TSB170038

Technical Service Bulletin

Fault Code 2387, 3616, or Turbocharger Actuator Sticking

Figure 1, EGR Cooler Heat Shield Crack.

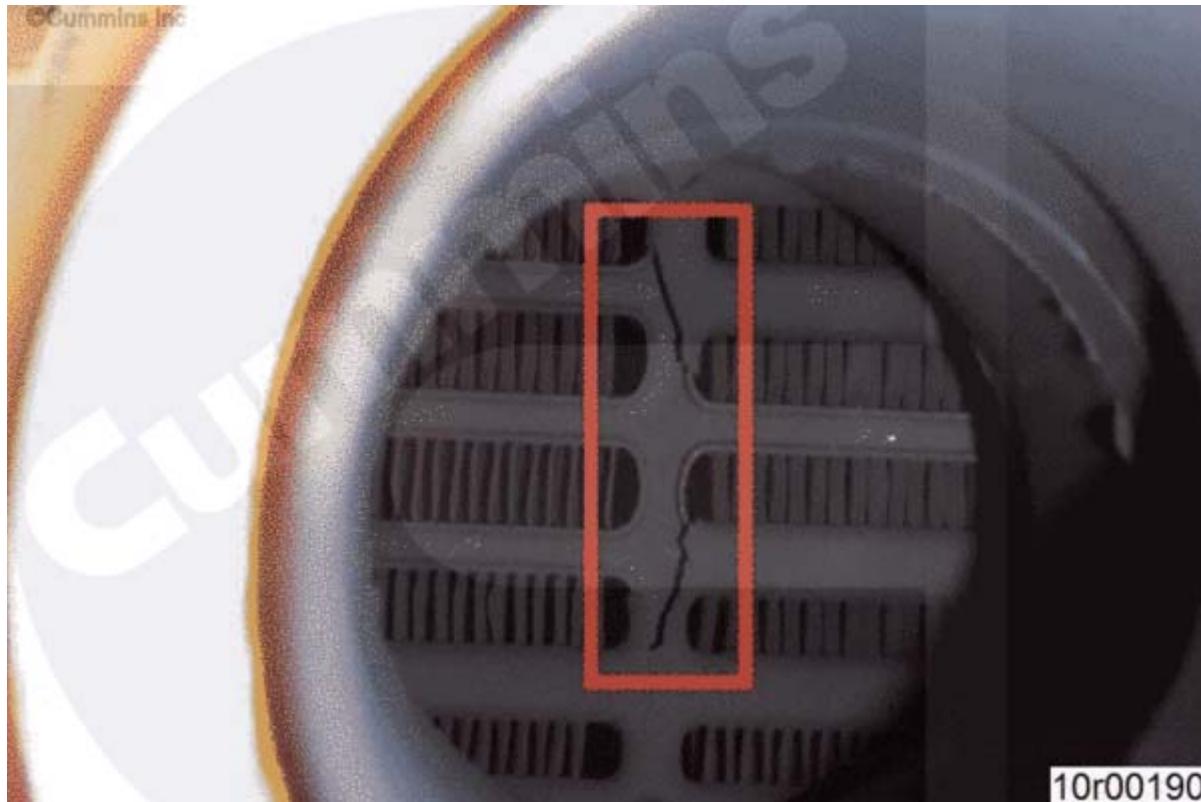
- The exhaust gas recirculation (EGR) cooler, Part Number 4337587, used in Service Kit, Part Number 4376532, has an internal heat shield at the gas inlet header. The

internal heat shield can crack in some instances. See Figures 1 and 2 below. Metal pieces from the internal heat shield can be ingested by the turbocharger, resulting in turbocharger nozzle vane damage and turbocharger actuator sticking.

- Follow published troubleshooting for FC2387 and/or FC3616.
- Cummins Inc. recommends replacing EGR cooler, Part Number 4337587, with EGR cooler, Part Number 3689035 (Service Kit, Part Number 4309398), to prevent future damage to turbocharger. See Figure 6 below.
- EGR cooler, Part Number 3689035, does **not** have an internal heat shield at inlet header plate.

Figure 5, EGR Cooler Part Number Example.

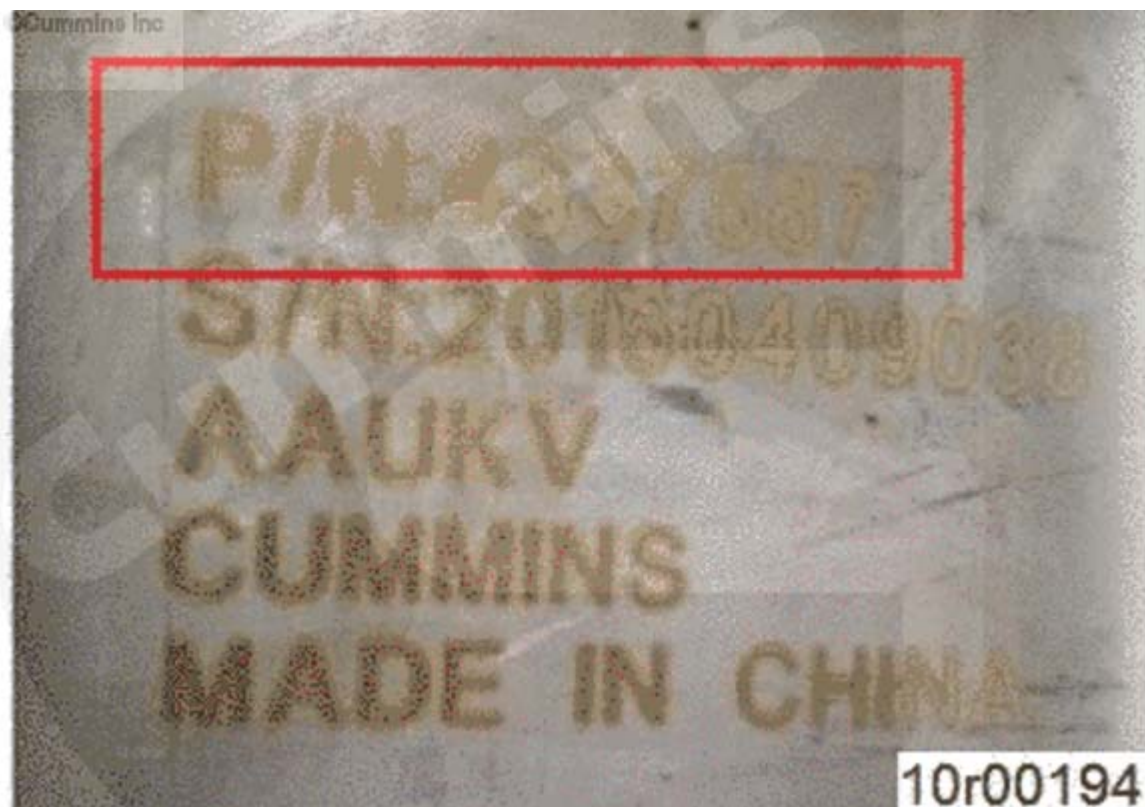
- FC2387 or FC3616 present.
- EGR cooler is part number 4337587. See Figures 3, 4, and 5.
- EGR cooler heat shield at inlet is cracked. See Figures 1 and 2 above.
